AVALON SUBDIVISION
PLANNED UNIT DEVELOPMENT
No. 06-027

SUBJECT: PUD# 06-027, Avalon

☐ APPROVED
☒ APPROVED WITH CONDITIONS
☐ DENIED

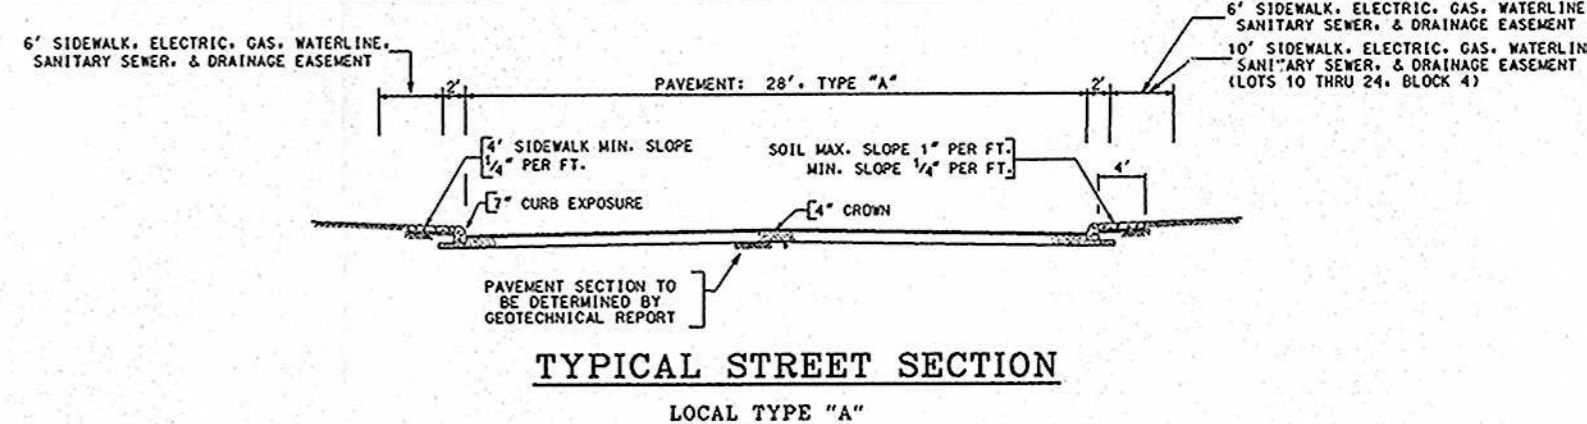
The dedicatory instrument(s) (Legal Instrument) for common areas and facilities must be approved by the City Attorney as to legal form prior to any plat recordation and shall be recorded at the same time as the plat. UDC 35-344(i)

- UDC 35-502(a)(9) Roadways.
- UDC 35-506(q) Sidewalks.
- All access roadways shall provide clear sight distance.

- The parkland provided is to be dedicated to the Home Owners Association.
- The parkland provided shall be shown as “Park” or Open Space” on a plat; UDC section 35-503(e) *Designation of Parkland*.
- The instruments creating the Home Owners Association are provided by the application for plat approval; UDC Section 35-503(e) *Designation of Parkland*.

- 100 year Flood Plain shown and buffering (if applicable)
- Significant recharge features and buffering (if applicable)
- Category letter for all site specific plats (if category 2 or 3, and Aquifer Protection Plan is required) (if applicable)

Additionally, a Water Pollution Abatement Plan or Contributing Zone Plan must be submitted to and approved by the Texas Commission on Environmental Quality (TCEQ) prior to construction.

The Avalon subdivision has approximately .401 acres that lie within the Edwards Aquifer Recharge Zone and shall remain undeveloped and will be included in the open space park area as depicted on PUD Plan # 06-027. Any wells found on site should be plugged, for plugging standards please contact Kirk Nixon at 233-3523. According to the Water Quality Ordinance #81491, Section 34-913, buffering may be required.
